Access Compliance Report

Public Rights-of-Way

(Curb Ramps)

Intersection ID: 27556	Main Street: LEDERER_AV	Cross Street: QUEARY_CT	Location:	N
ADA ID: E6A74F3EE143	Ramp Type: Perp	Initial Pass/Fail: Fail	Overall Compliance: No	Severity Score: 25

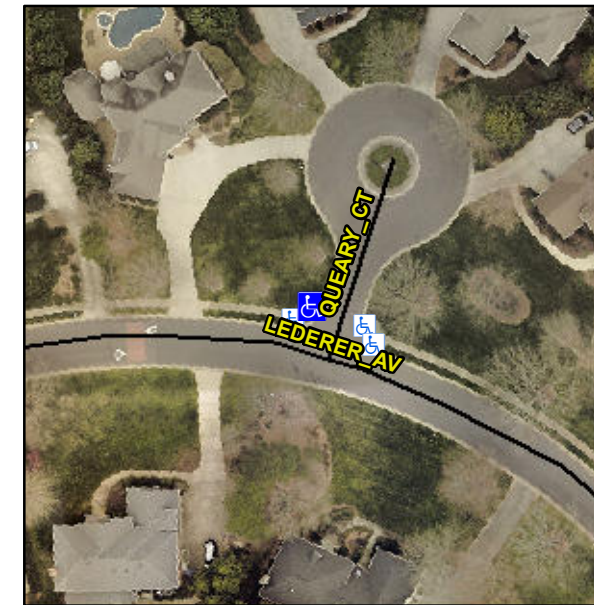
Not Found, R304.2.2, R304.5.3

Compliance	Description	Data	Compliance	Description	Data
N/A	Ramp Length (in)	48.0	No	Ramp Slope (%)	9.1
Yes	Ramp Width (in)	48.0	No	Ramp XSlope (%)	6.4
N/A	Flare Type LT	N/A	N/A	Flare Type RT	N/A
N/A	Flare Slope LT (%)	N/A	N/A	Flare Slope RT (%)	N/A
N/A	Flare Traversable LT?	N/A	N/A	Flare Traversable RT?	N/A
N/A	Landing Length (in)	N/A	N/A	DWS Provided?	N/A
N/A	Landing Width (in)	N/A	N/A	DWS Contrast?	N/A
N/A	Landing Slope (%)	N/A	N/A	DWS Length (in)	N/A
N/A	Landing X Slope (%)	N/A	N/A	DWS Full Width?	N/A
N/A	Landing Curb? (Y/N)	N/A	N/A	DWS Offset (in)	N/A
N/A	Shared Landing?	N/A			
N/A	Gutter Ponding?	N/A	N/A	Gutter Slope (%)	N/A
N/A	Gutter Lip Ht (in)	N/A	N/A	Gutter X Slope (%)	N/A
N/A	Painted X Walk1?	No	N/A	Painted X Walk2?	N/A
	X Walk 1 Direction	To SE		X Walk 2 Direction	N/A
N/A	X Walk 1 Width (in)	N/A	N/A	X Walk 2 Width (in)	N/A
	X Walk 1 Slope (%)	1.2		X Walk 2 Slope (%)	N/A
	X Walk 1 X Slope (%)	6.3		X Walk 2 X Slope (%)	N/A

Remove & Replace Entire Ramp.
